Product Change Notification

PCN-ICC-1761-2018

Business Unit	Product Line Code	Type of Change	Action	Date of Issue
ICC - Industrial Cabinet	BE1	Product Change Notification	Notify Distributors and Field	6/21/2018

Description for Product Change Notification

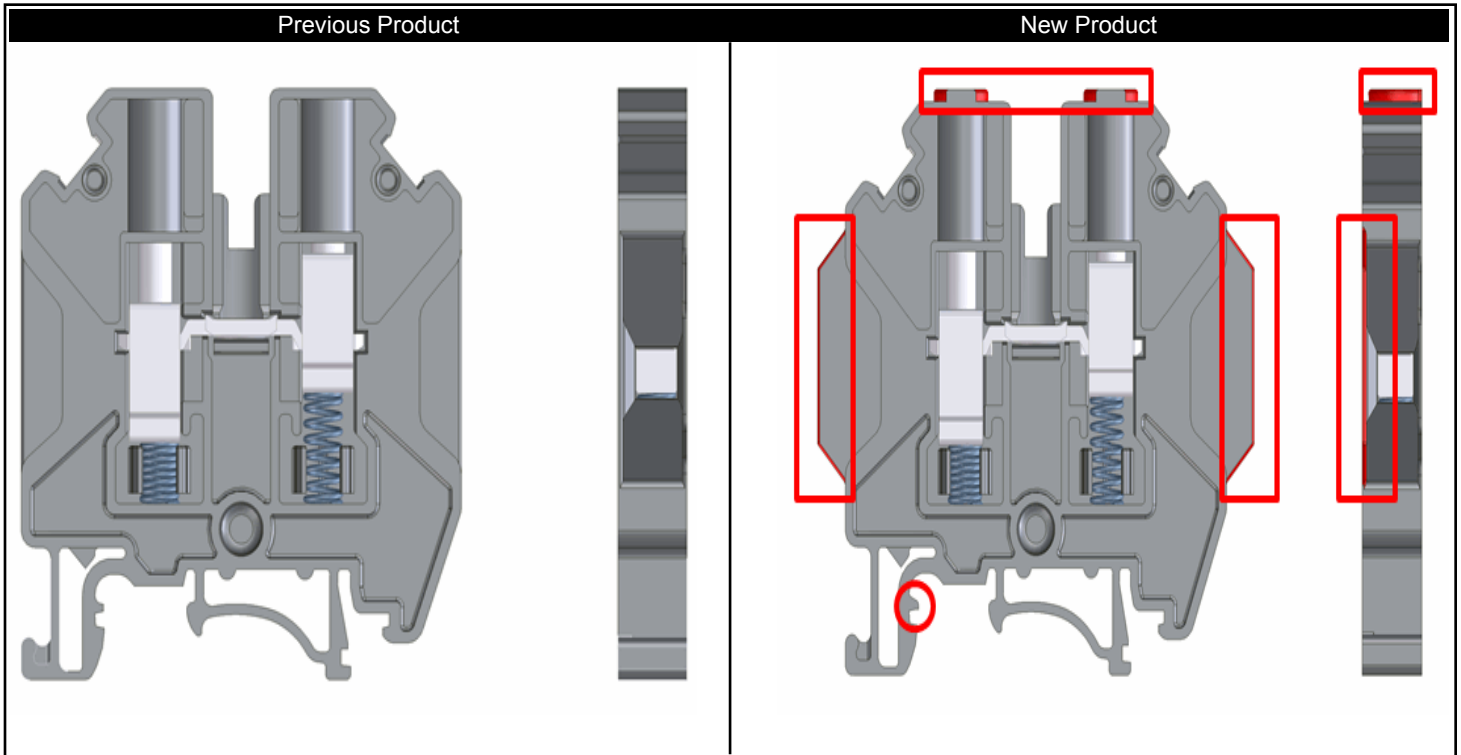
The USST feed through terminal block will be improved by new insulating housings with extended air and creepage distances, additional housing walls and higher turn screw shafts.
